CHANGES FOR REPLACEMENT FROM RELAY RA221 TO RA25A

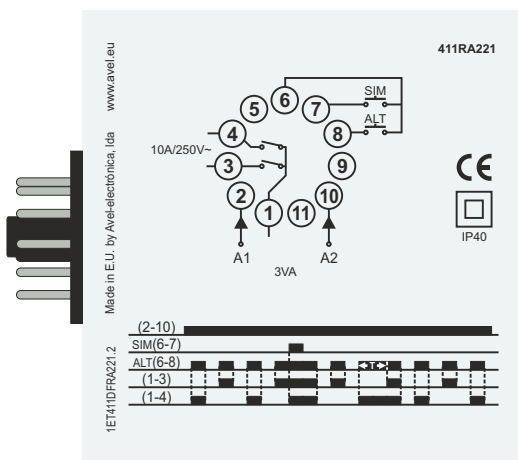
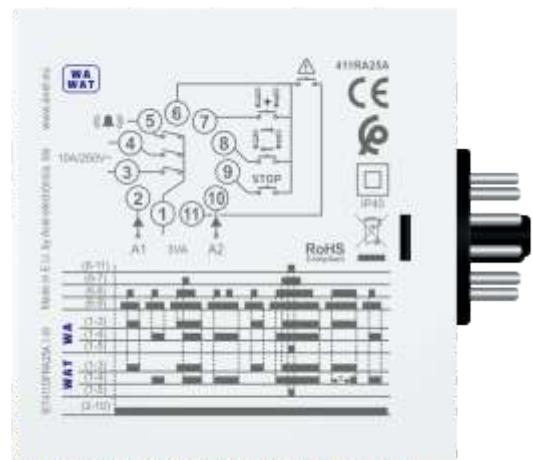
Add a shunt connection between pins 8 and 9 of the RA25A relay;
Keep the remaining connections.

NOTE 1: The RA25A relay switch should be placed in the position corresponding to the WAT application;

NOTE 2: 10-minute delay for automatic activation of simultaneity.
